## TECHNICAL SERVICE BULLETIN

### Slow Fill And/Or Illuminated MIL With DTCs P0171, P0174, P0451, P0455, P0456, P0496 And/Or P1450 - Built On Or Before 30-Nov-2020

**21-2106**

<b>Ford</b> 2017-2021 Transit
----------------------------------

Figure 2

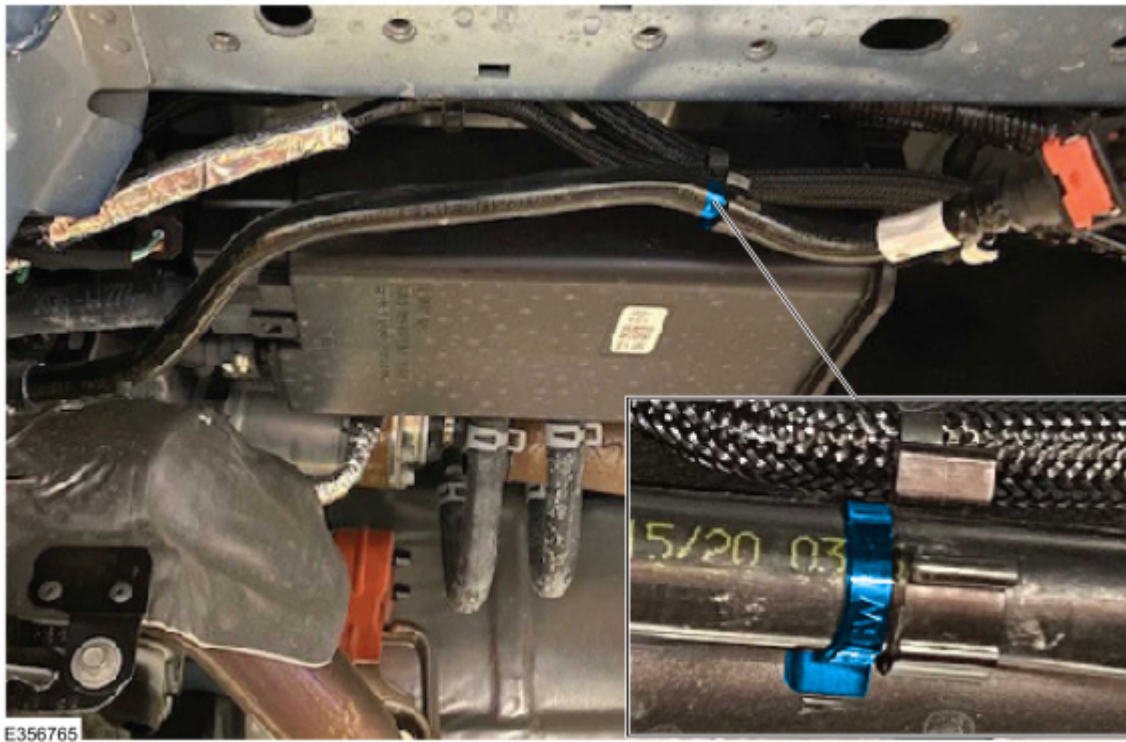
**Issue:** Some 2017-2021 Transit vehicles built on or before 30-Nov-2020 may experience a slow fill condition and/or illuminated malfunction indicator lamp (MIL) with diagnostic trouble codes (DTCs) P0171, P0174, P0451, P0455, P0456, P0496 and/or P1450. This may be due to a kinked evaporator emissions fresh air vent line. To correct this condition, follow the Service Procedure to attach a zip tie to the fresh air vent line.

2. Return the fresh air vent line to its original position.
3. Attach a zip tie next to the C-clamp on the shepherds hook side. Make sure to align the zip tie knuckle on the opposite side of the C-clamp opening. (Figure 2)
